SUBJECT: Beaver Valley Power Station - Unit No. 2  
Docket No. 50-412  
Response to DSER Outstanding Issue 197

Attached is revised FSAR material in response to Outstanding Issue 197 of the Draft Safety Evaluation Report. This revision addresses those concerns raised by the reviewer in meetings on August 30, 1984, and September 26, 1984. This information will be incorporated in the FSAR upon acceptance by the reviewer.

PHYSICAL INDEPENDENCE OF ELECTRIC SYSTEMS (SEPTEMBER 1978)

FIGURE 8.3-16

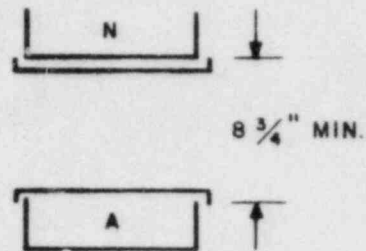
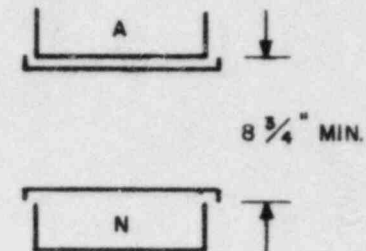
In the GPA, where an 8 3/4 in. minimum vertical tray spacing is maintained between redundant Class 1E trays or between non-Class 1E and Class 1E trays, a tray cover on the top of the lower tray and a tray cover on the bottom of the upper tray are installed as shown on Figure 8.3-16, Details A, B, and C. In the GPA, where the 8 3/4 in. minimum vertical tray spacing cannot be maintained between redundant Class 1E trays or between non-Class 1E and Class 1E, the free-air space may be reduced to 1 in. where a tray cover on the top of the lower tray and a tray cover on the bottom of the upper tray are installed in the same configurations as shown on Figure 8.3-16, Details A, B, C. Free-air space is measured from tray cover to tray cover.

In the GPA, where 8 3/4 in. minimum vertical spacing between Class 1E and non-Class 1E trays is maintained and tray covers are provided in accordance with Figure 8.3-16, Detail C, where a Class 1E cable enters the Class 1E tray, the separation between the Class 1E cable and the non-Class 1E tray may be reduced to 6 in. as shown on Figure 8.3-40.

In the GPA, where 8 3/4 in. minimum vertical spacing between non-Class 1E and Class 1E trays is maintained and tray covers are provided in accordance with Figure 8.3-16, Detail B, where a non-Class 1E cable enters the non-Class 1E tray the separation between the non-Class 1E cable and the Class 1E tray may be reduced to 6 in. as shown on Figure 8.3-41.

FIGURE 8.3-17

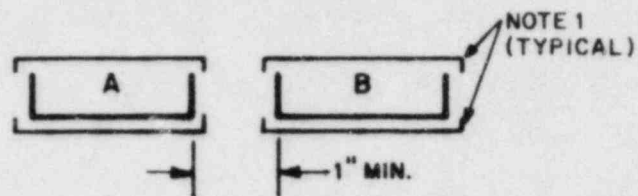
In the GPA, where a 1 in. minimum horizontal tray spacing is maintained between redundant Class 1E trays or between non-Class 1E and Class 1E trays, tray covers on the top and bottom of both trays are installed as shown on Figure 8.3-17, Details A and B.

FIGURE 8.3-18  
GENERAL PLANT AREAS (GPA)  
ACCEPTABLE SEPARATION  
ARRANGEMENT  
BEAVER VALLEY POWER STATION-UNIT 2  
FINAL SAFETY ANALYSIS REPORT

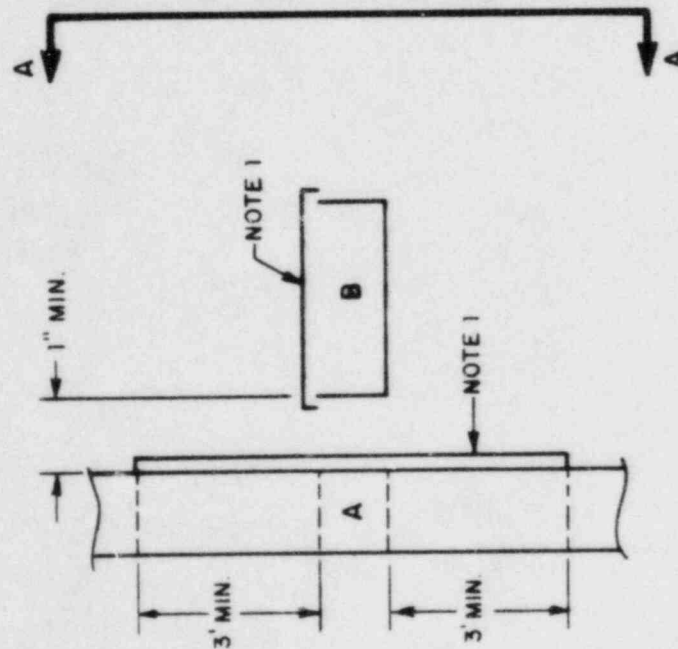
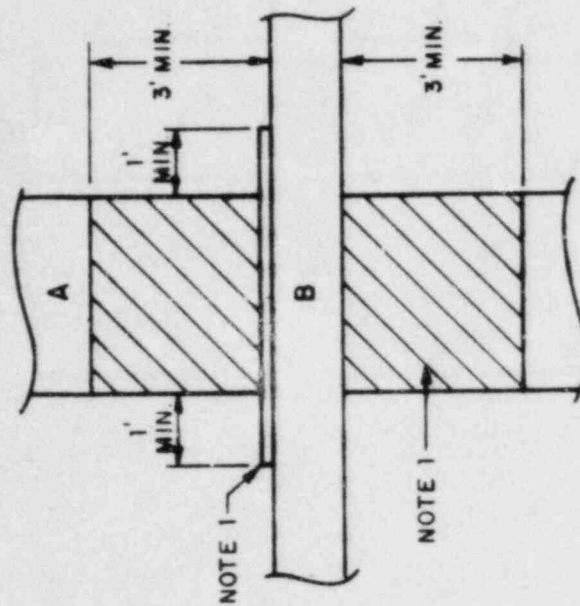
In the GPA, where a 1 in. minimum horizontal tray spacing is maintained between a Class 1E tray running vertically and a redundant Class 1E tray running horizontally, tray covers on both trays are installed as shown on Figure 8.3-18.

FIGURE 8.3-19  
GENERAL PLANT AREAS (GPA)  
ACCEPTABLE SEPARATION  
ARRANGEMENT  
BEAVER VALLEY POWER STATION-UNIT 2  
FINAL SAFETY ANALYSIS REPORT

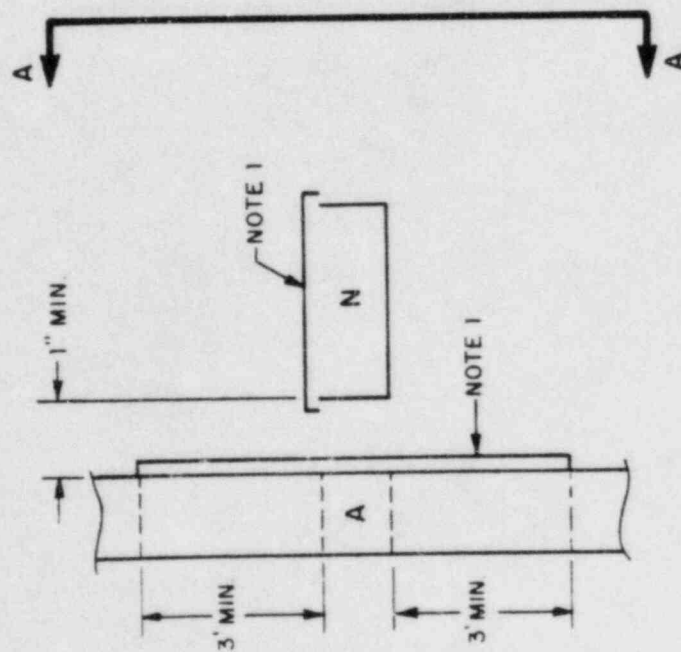
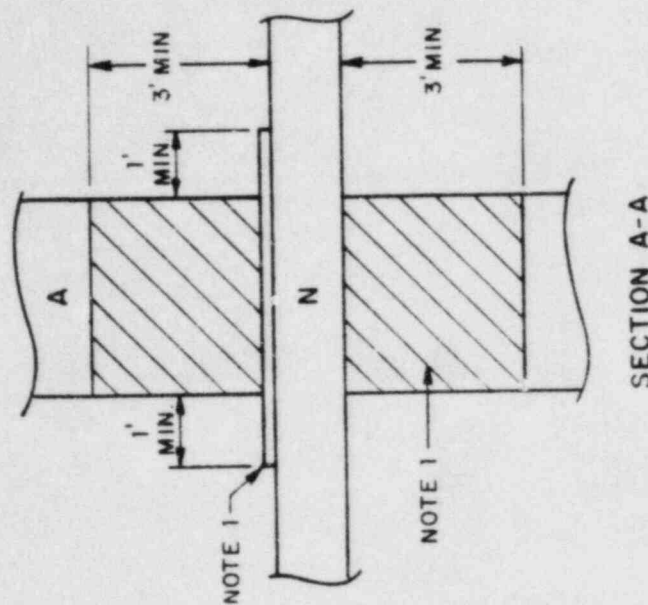
In the GPA, where a 1 in. minimum horizontal tray spacing is maintained between a Class 1E tray running vertically and a non-Class 1E tray running horizontally, tray covers on both trays are installed as shown on Figure 8.3-19.

FIGURE 8.3-20  
GENERAL PLANT AREAS (GPA)  
ACCEPTABLE SEPARATION  
ARRANGEMENT  
BEAVER VALLEY POWER STATION-UNIT 2  
FINAL SAFETY ANALYSIS REPORT

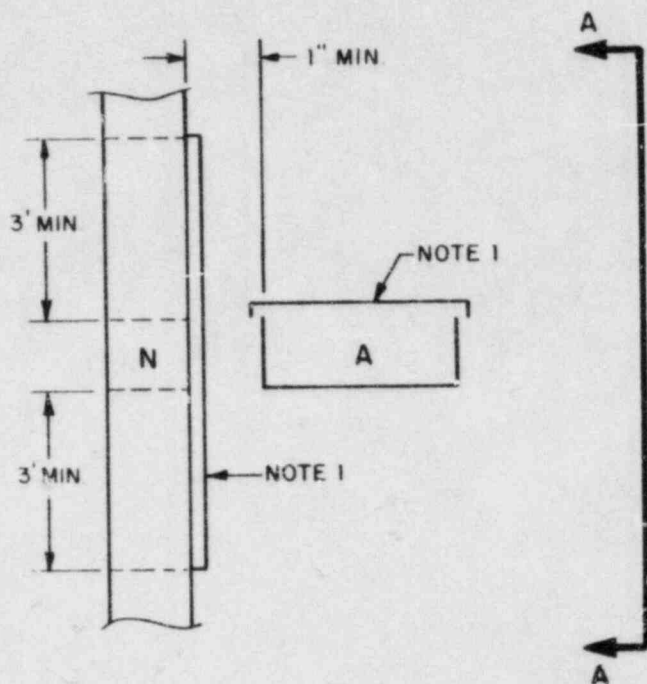
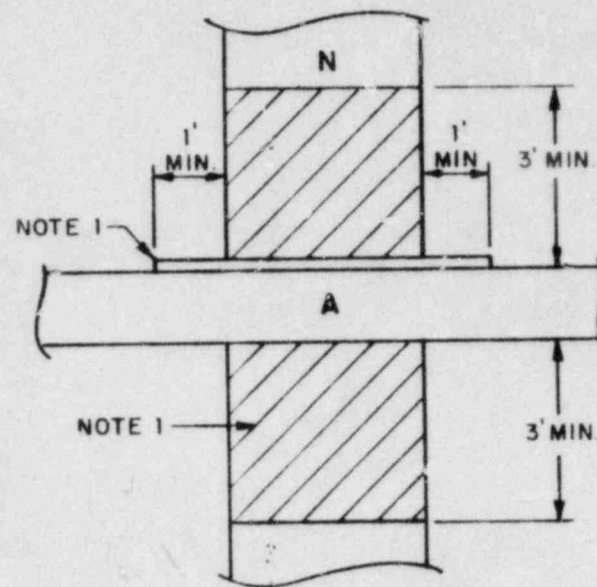
In the GPA, where a 1 in. minimum horizontal tray spacing is maintained between a non-Class 1E tray running vertically and a Class 1E tray running horizontally, tray covers on both trays are installed as shown on Figure 8.3-20.

**FIGURE 8.3-21**

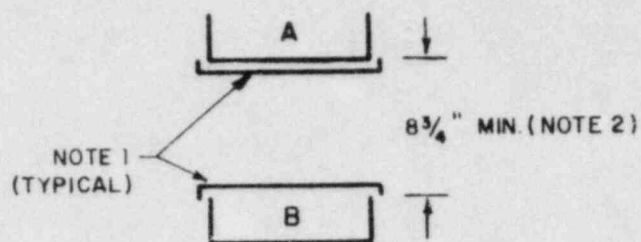
In the CSA, where an 8 3/4 in. minimum vertical tray spacing is maintained between redundant Class 1E trays, tray covers on the bottom of the upper tray and on the top of the lower tray are installed as shown on Figure 8.3-21, Detail A.

In the CSA, where a 1 in. minimum horizontal tray spacing is maintained between redundant Class 1E trays, tray covers on the top and bottom of both trays are installed as shown on Figure 8.3-21, Detail B.

**FIGURE 8.3-22**

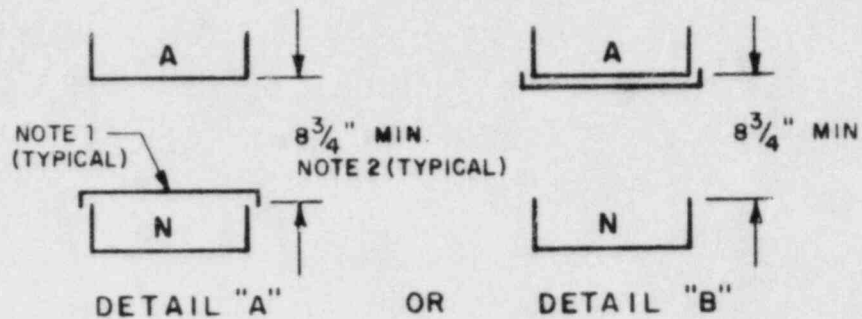
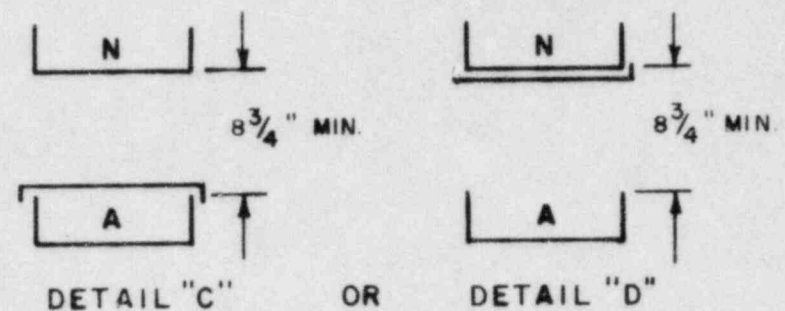
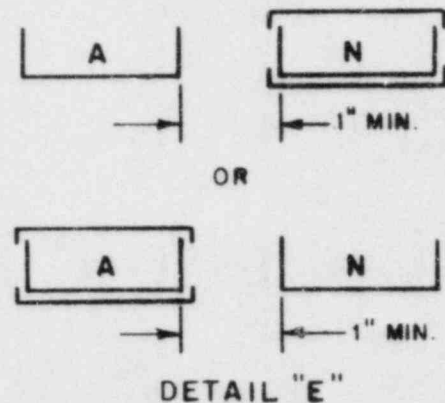
Where plant arrangement in the control room or cable spreading room precludes the minimum vertical separation, but a spacing of 8 3/4 in. (i.e., the minimum vertical tray spacing) is maintained, a tray cover on the top of the lower tray, or a tray cover on the bottom of the upper tray, or a barrier interposed between the Class 1E and the non-Class 1E circuits provides the necessary separation, as shown on Figures 8.3-22 (Details A, B, C, and D), 28 and 29.

raceway or cable and a barrier is 1 in. as shown on Figures 8.3-22 (Detail E), 34, 35, 38, and 39.

In the CSA, where an 8 3/4 in. minimum vertical tray spacing is maintained between a non-Class 1E tray and a Class 1E tray, a tray cover on the bottom of the upper tray or a tray cover on the top of the lower tray is installed as shown on Figure 8.3-22, Details A, B, C, and D.

In the CSA, where a 1 in. minimum horizontal tray spacing is maintained between non-Class 1E and Class 1E trays, tray covers on the top and bottom of one of the trays are installed as shown on Figure 8.3-22, Detail E.

FIGURE 8.3-23  
CABLE SPREADING AREAS (CSA)  
ACCEPTABLE SEPARATION  
ARRANGEMENT  
BEAVER VALLEY POWER STATION-UNIT 2  
FINAL SAFETY ANALYSIS REPORT

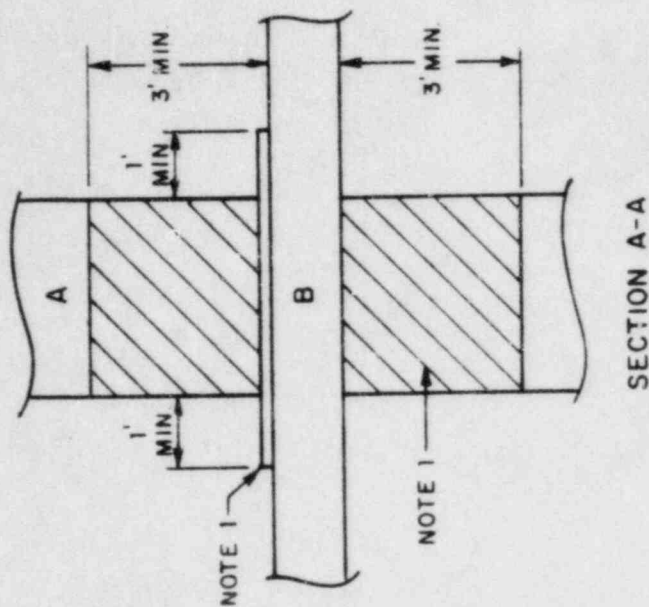
In the CSA, where a 1 in. minimum horizontal tray spacing is maintained between a Class 1E tray running vertically and a redundant Class 1E tray running horizontally, tray covers on both trays are installed as shown on Figure 8.3-23.

FIGURE 8.3-24  
CABLE SPREADING AREAS (CSA)  
ACCEPTABLE SEPARATION  
ARRANGEMENT  
BEAVER VALLEY POWER STATION UNIT 2  
FINAL SAFETY ANALYSIS REPORT

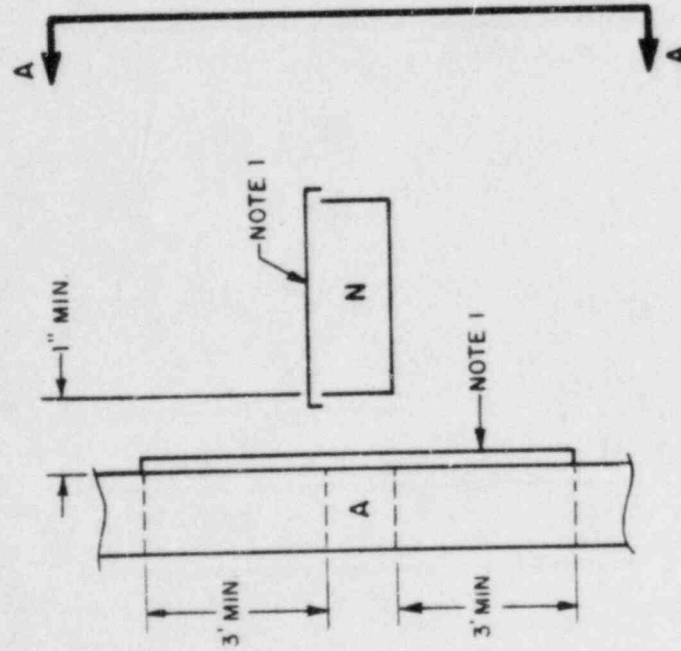
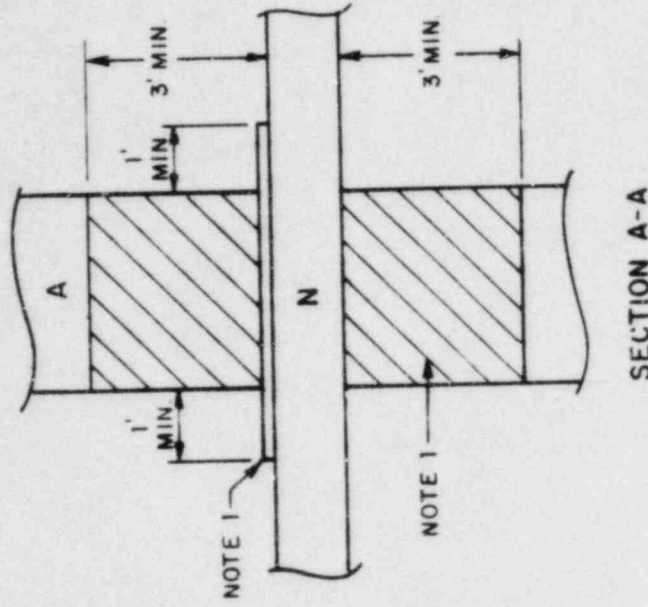
In the CSA, where a 1 in. minimum horizontal tray spacing is maintained between a Class 1E tray running vertically and a non-Class 1E tray running horizontally, tray covers on both trays are installed as shown on Figure 8.3-24.

FIGURE 8.3-25  
CABLE SPREADING AREAS (CSA)  
ACCEPTABLE SEPARATION  
ARRANGEMENT  
BEAVER VALLEY POWER STATION-UNIT 2  
FINAL SAFETY ANALYSIS REPORT

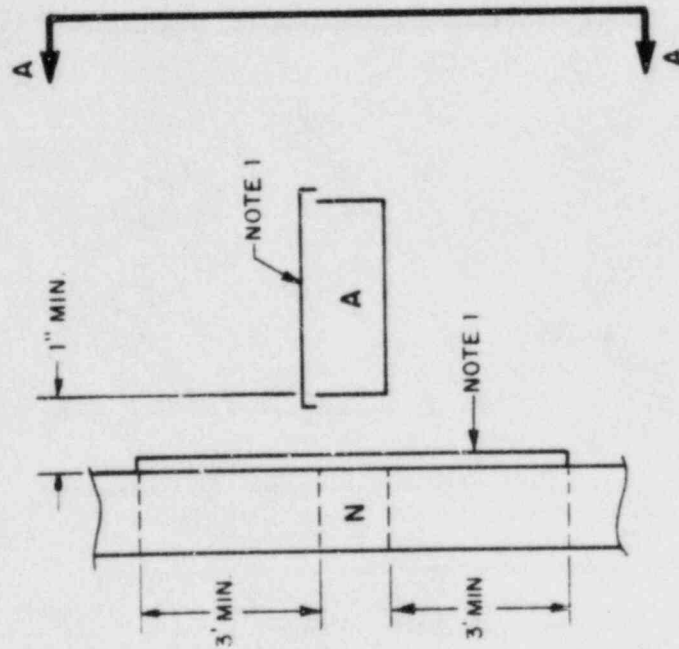
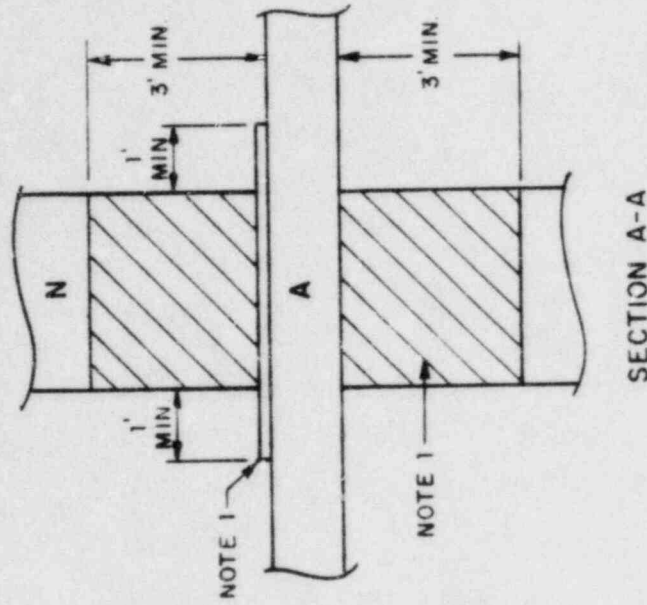
In the CSA, where a 1 in. minimum horizontal tray spacing is maintained between a non-Class 1E tray running vertically and a Class 1E tray running horizontally, tray covers on both trays are installed as shown on Figure 8.3-25.

**FIGURE 8.3-26**

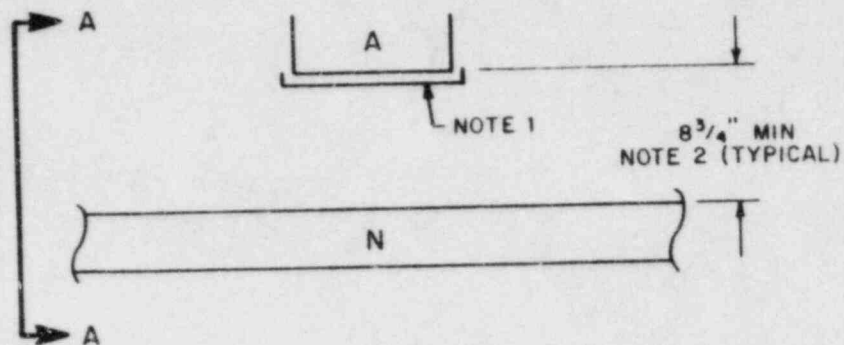
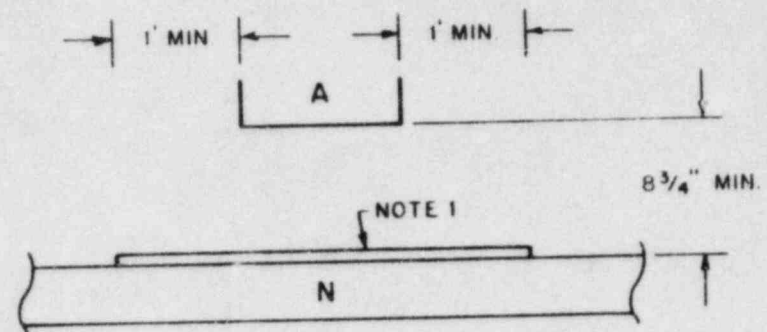
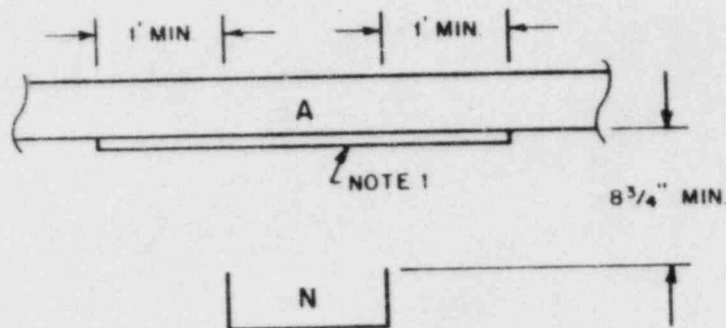
Where plant arrangement in non-hazardous general plant areas for perpendicular crossings precludes the minimum vertical separation but a spacing of 8 3/4 in. (i.e., the minimum vertical tray spacing) is maintained, a tray cover on the lower tray, or a tray bottom on the upper tray, or a barrier interposed between the Class 1E and the non-Class 1E circuits provides the necessary separation as shown on Figures 8.3-26 and 27.

In the GPA, where an 8 3/4 in. minimum vertical tray spacing is maintained between Class 1E and non-Class 1E vertical trays which cross in the horizontal plane, a tray cover on the top of the lower tray or on the bottom of the upper tray is installed as shown on Figure 8.3-26.

**FIGURE 8.3-27  
GENERAL PLANT AREAS (GPA)  
ACCEPTABLE SEPARATION  
ARRANGEMENTS  
BEAVER VALLEY POWER STATION-UNIT 2  
FINAL SAFETY ANALYSIS REPORT**

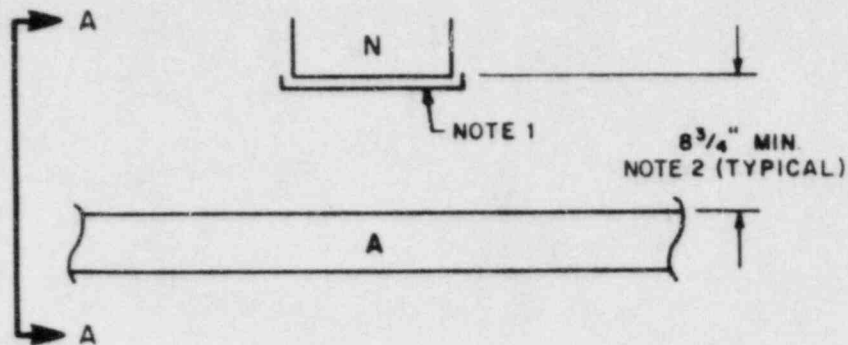
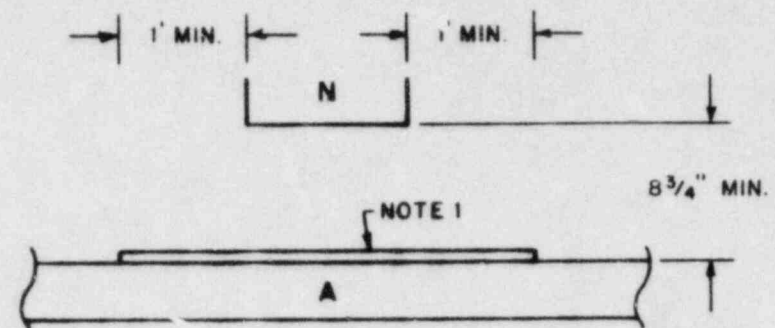
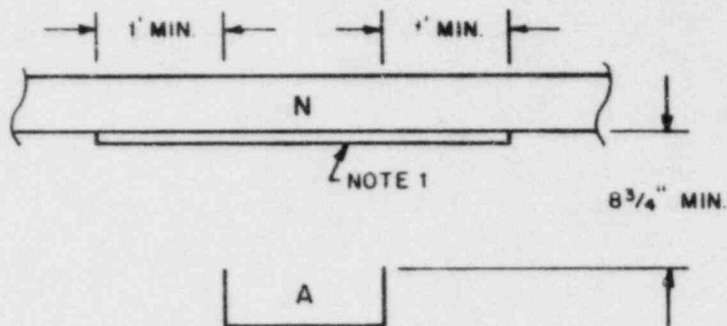
In the GPA, where an 8 3/4 in. minimum vertical tray spacing is maintained between non-Class 1E and Class 1E vertical trays which cross in the horizontal plane, a tray cover on the top of the lower tray or on the bottom of the upper tray is installed as shown on Figure 8.3-27.

**FIGURE 8.3-28  
CABLE SPREADING AREAS (CSA)  
ACCEPTABLE SEPARATION  
ARRANGEMENTS  
BEAVER VALLEY POWER STATION-UNIT 2  
FINAL SAFETY ANALYSIS REPORT**

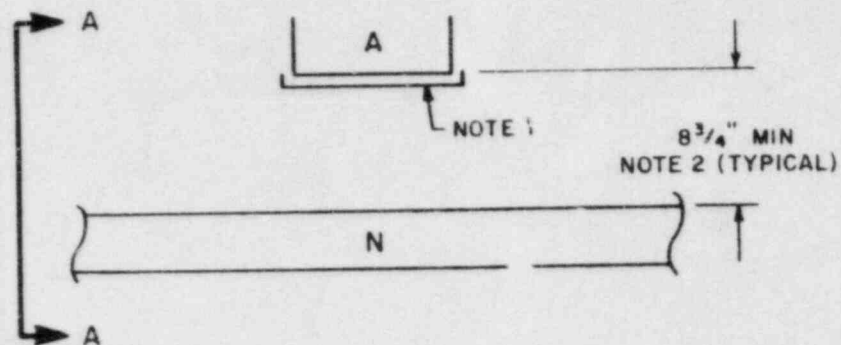
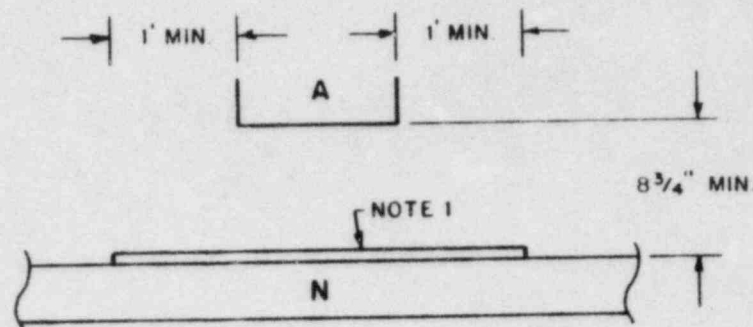
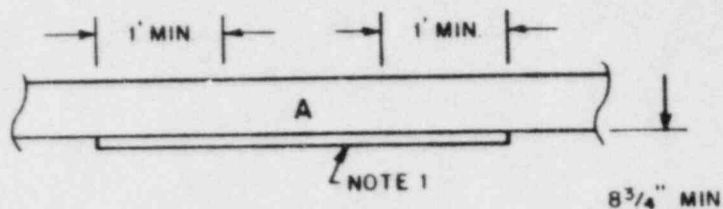
In the CSA, where an 8 3/4 in. minimum vertical tray spacing is maintained between Class 1E and non-Class 1E vertical trays which cross in the horizontal plane, a tray cover on the top of the lower tray or on the bottom of the upper tray is installed as shown on Figure 8.3-28.

**FIGURE 8.3-29  
CABLE SPREADING AREAS (CSA)  
ACCEPTABLE SEPARATION  
ARRANGEMENTS  
BEAVER VALLEY POWER STATION-UNIT 2  
FINAL SAFETY ANALYSIS REPORT**

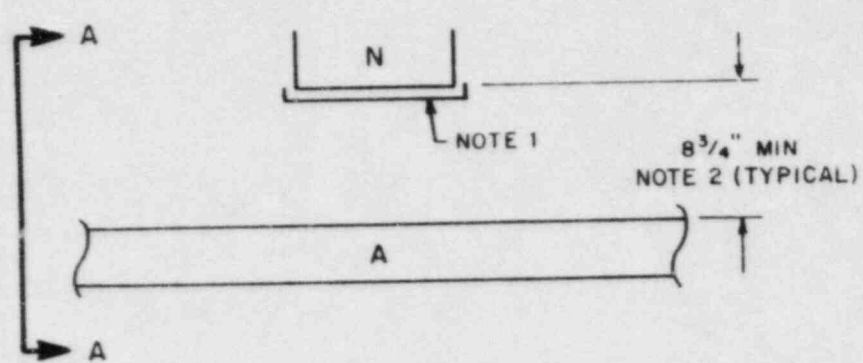
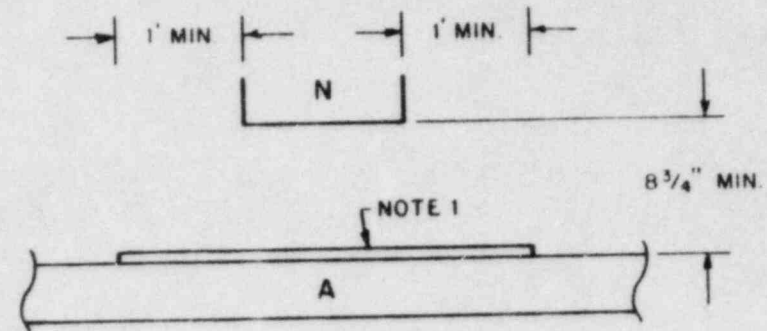
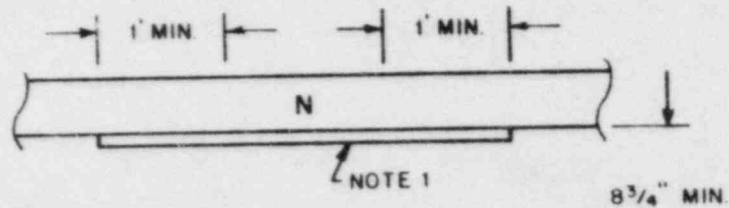
In the CSA, where an 8 3/4 in. minimum vertical tray spacing is maintained between non-Class 1E and Class 1E vertical trays which cross in the horizontal plane, a tray cover on the top of the lower tray or on the bottom of the upper tray is installed as shown on Figure 8.3-29.

FIGURE 8.3-30

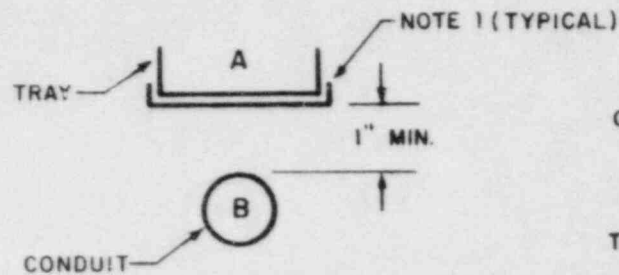
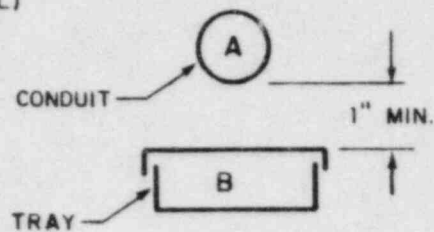
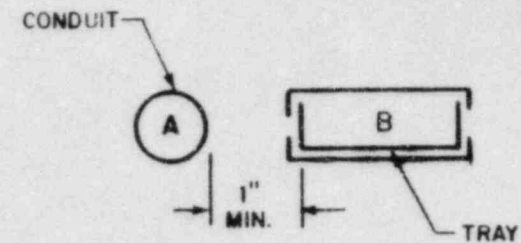
In the GPA, vertical separation between a Class 1E tray and a redundant Class 1E conduit may be reduced to 1 in., where a tray cover on the bottom of the tray is installed as shown on Figure 8.3-30, Detail A.

In the GPA, vertical separation between a Class 1E conduit and a redundant Class 1E tray may be reduced to 1 in., where a tray cover on the top of the tray is installed as shown on Figure 8.3-30, Detail B.

In the GPA, horizontal separation between a Class 1E conduit and a redundant Class 1E tray may be reduced to 1 in., where tray covers on the top and bottom of the tray are installed as shown on Figure 8.3-30, Detail C.
